- ☐ **Cat-I** Approved. Good for Manufacturing/Construction/Fabrication
- ☑ **Cat-I*** Approved with minor comments. No resubmission is required. To be incorporated in As-Built. Good for Manufacturing/ Construction/ Fabrication subject to incorporation of comments.
- ☐ **Cat-II** Approved. Released for Manufacturing/fabrication/construction subjected to incorporation of comments. Modification as Noted. Resubmission is required.
- ☐ **Cat-III** Not Approved
- ☐ **Cat-IV** For Information & Records

Project:
ADANI DEFENCE & AEROSPACE HYDERABAD

Building:
HELICOPTER COMPLEX (PEB-9)

Drawing Title:
INDEX SHEET

ROOF SHEETING PLAN

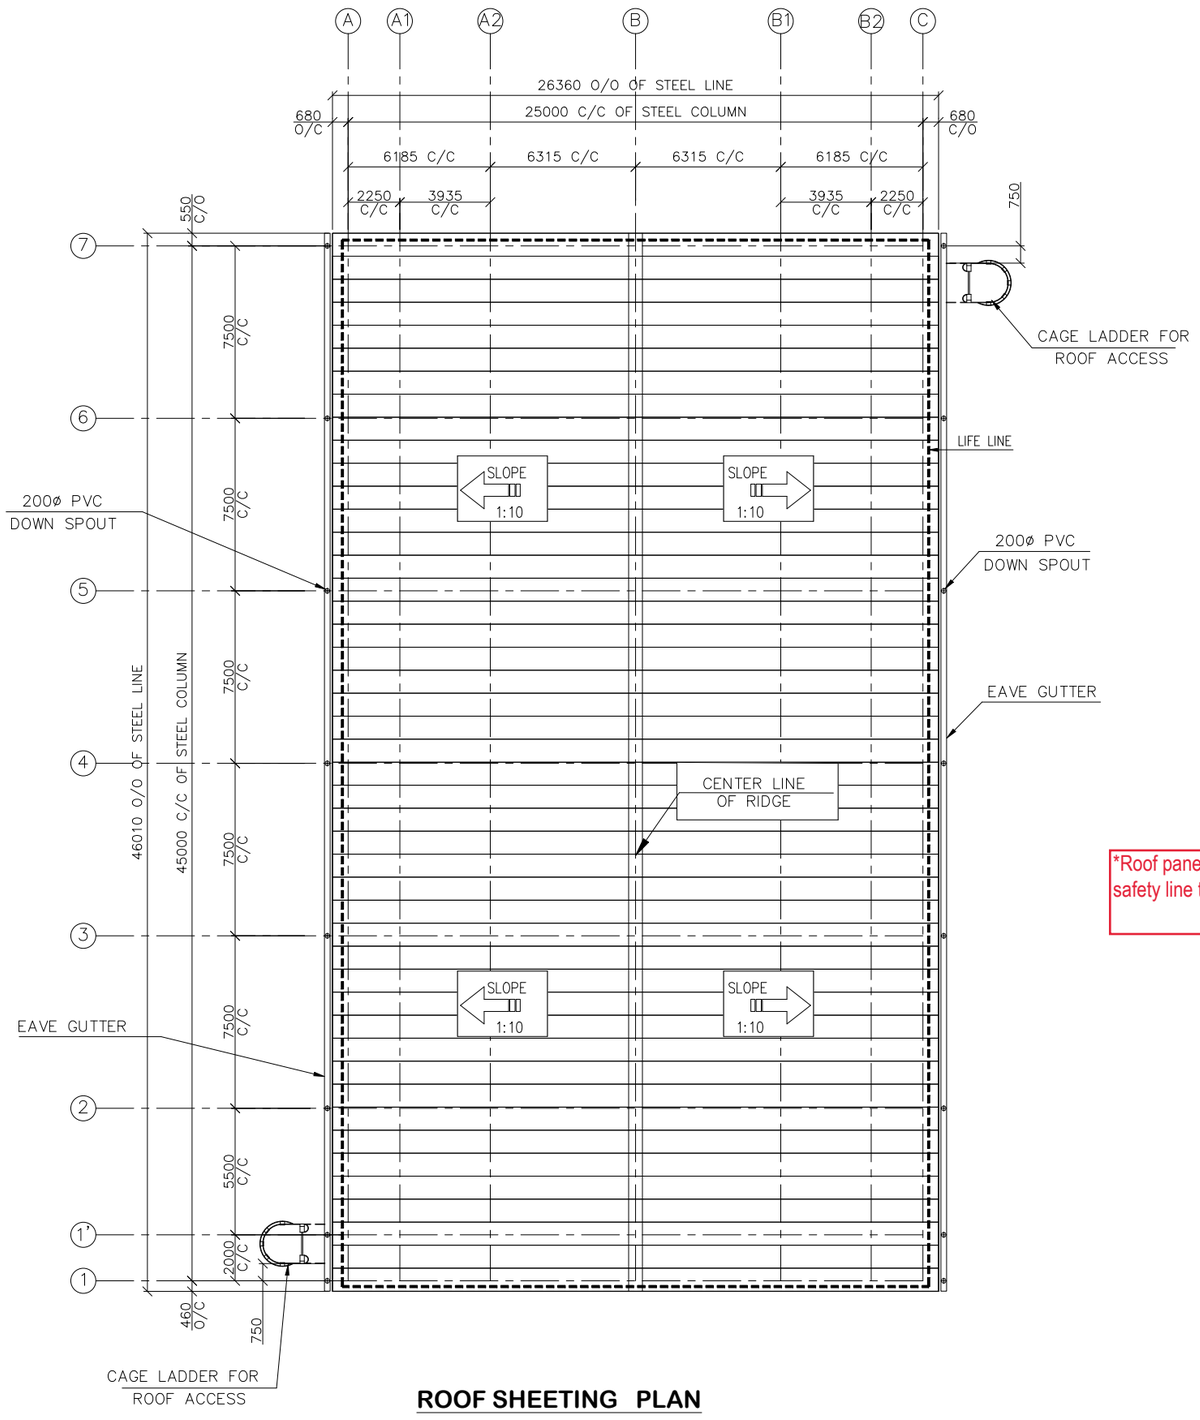
*Roof panel to be single length
safety line to be provided at the roof level

FRAME CROSS SECTION @ GL-1'

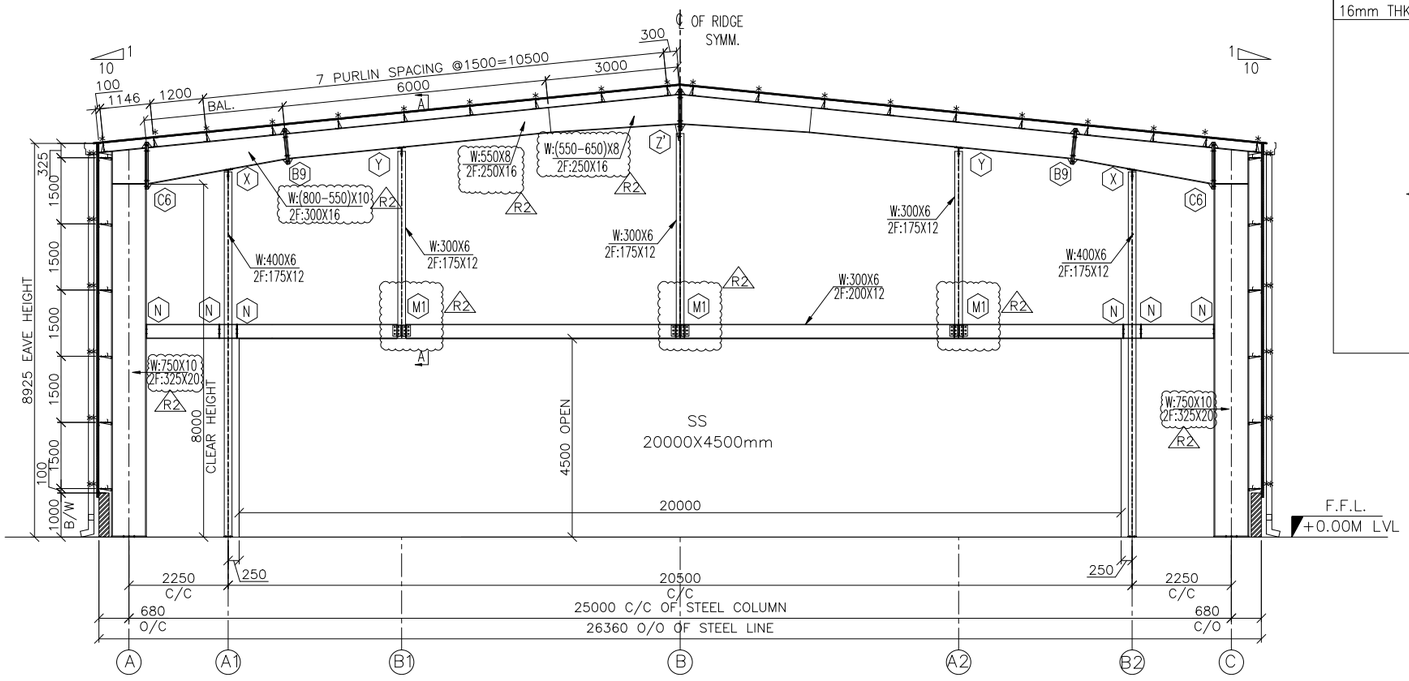
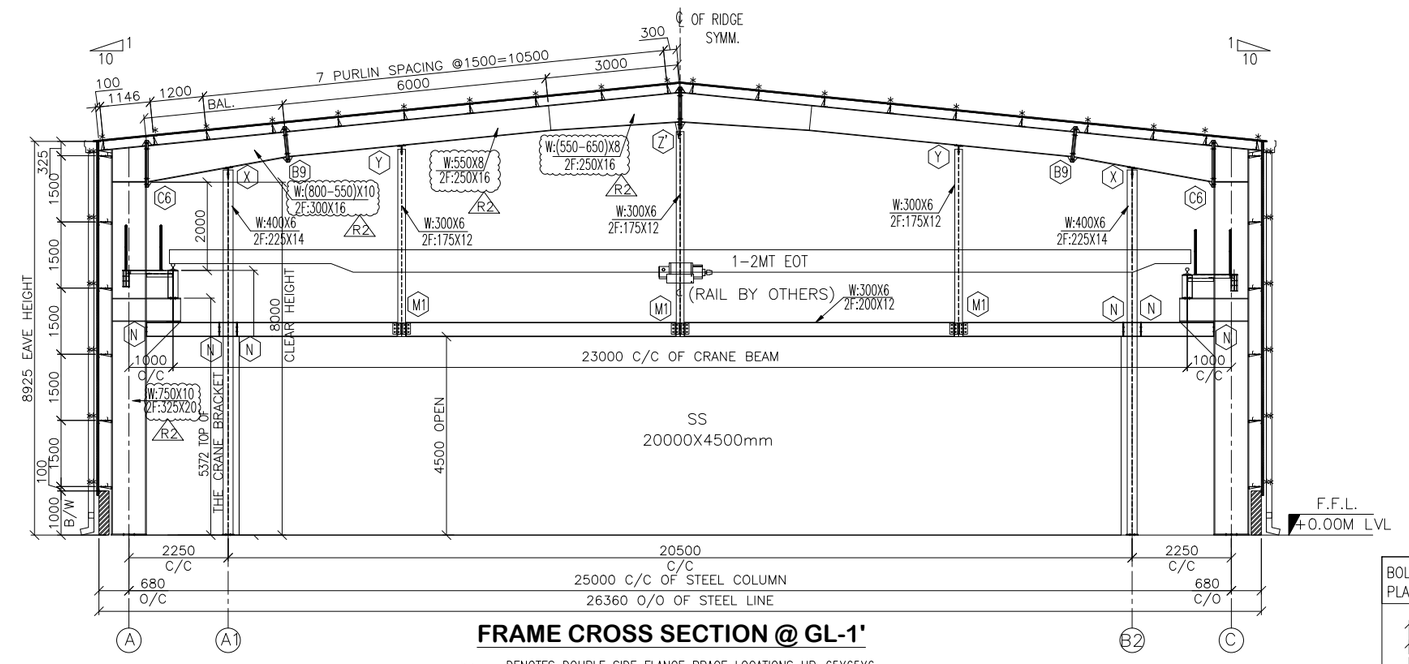
Make this a cleat connection.

DETAIL OF Z'

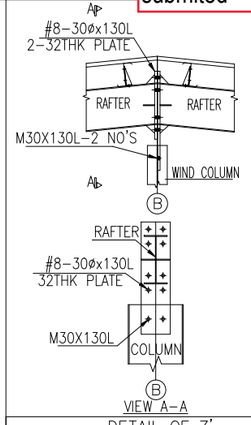
*20 thk. plate to be used for connection.
*Design to be submited

CRANE BEAM BRACE CONNECTION @ COLUMN

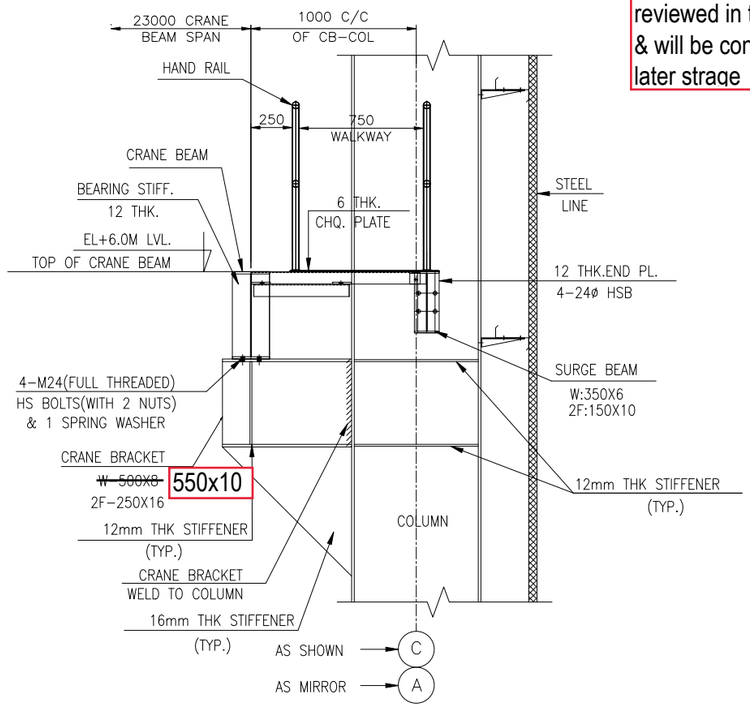
This connection will be reviewed in tekla model & will be confirmed at later stage
